DEVELOPMENT REVIEW COMMITTEE (DRC) COMMENT REPORT

PROJECT NAME: Healthy Housing Foundation - Residential

CASE NUMBER: R18069

REQUEST: Site Plan Level II Review: 680 Multifamily
Residential Units in Downtown

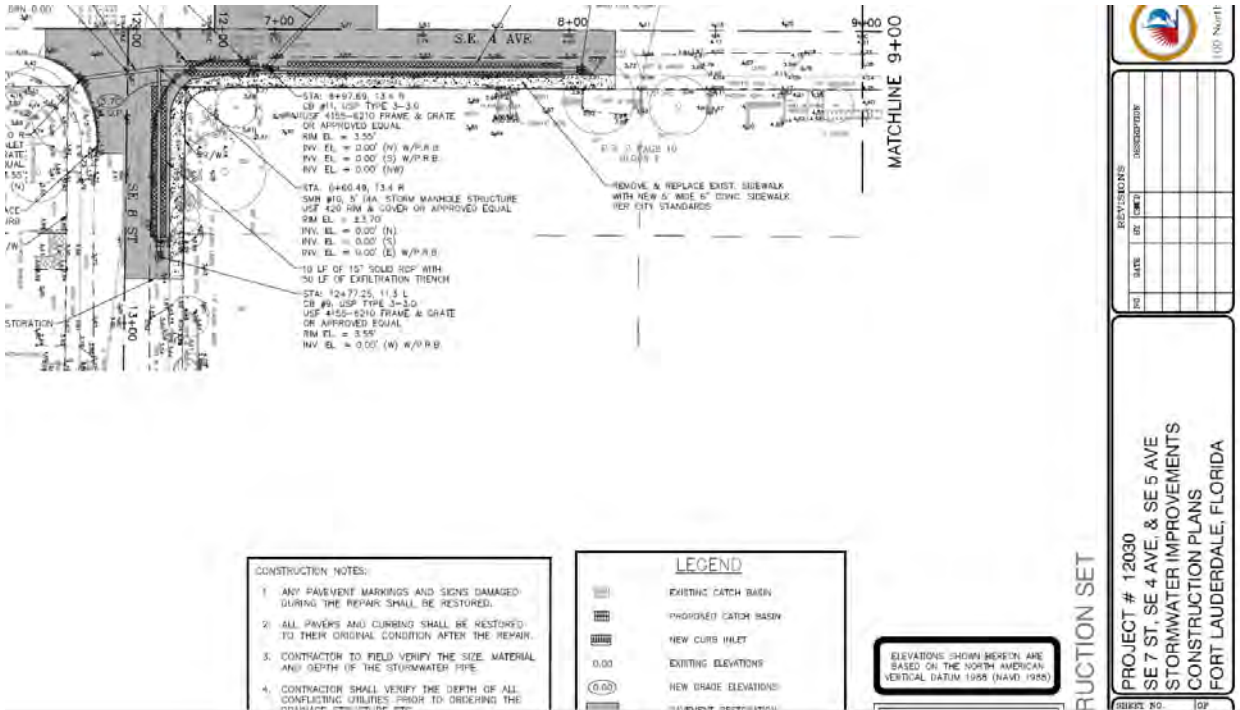
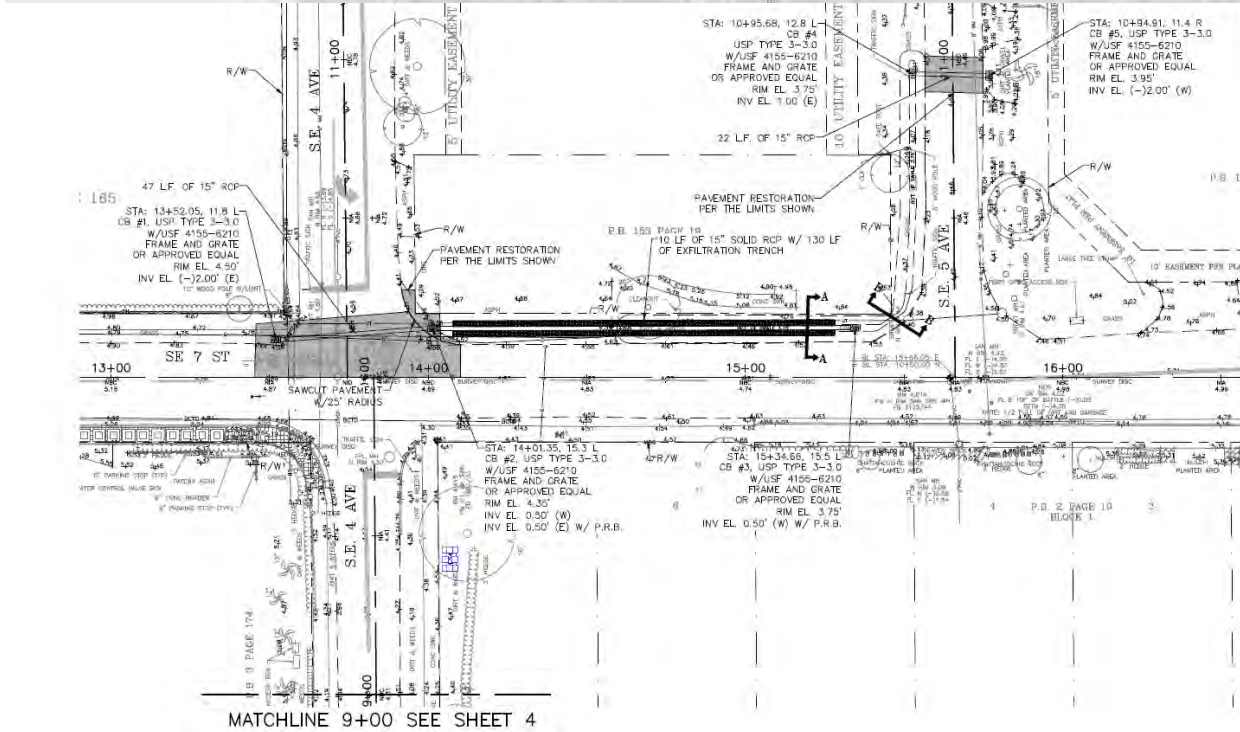
The City owns and maintains stormwater infrastructure & grass swales adjacent to the proposed development as shown in the snips of City Project P12030 provided at the end of this report. The following comments pertain to possible impacts of the proposed development and/or construction activities to the existing condition of the City's stormwater assets. The applicant shall provide an itemized response letter addressing the following comments:

- a) Contractor shall provide CCTV videotapes to City STW OPS of the existing stormwater system to the limits shown with green line work in the storm map provided at the end of this report in order to document the PRE and POST construction conditions of the City's storm system.
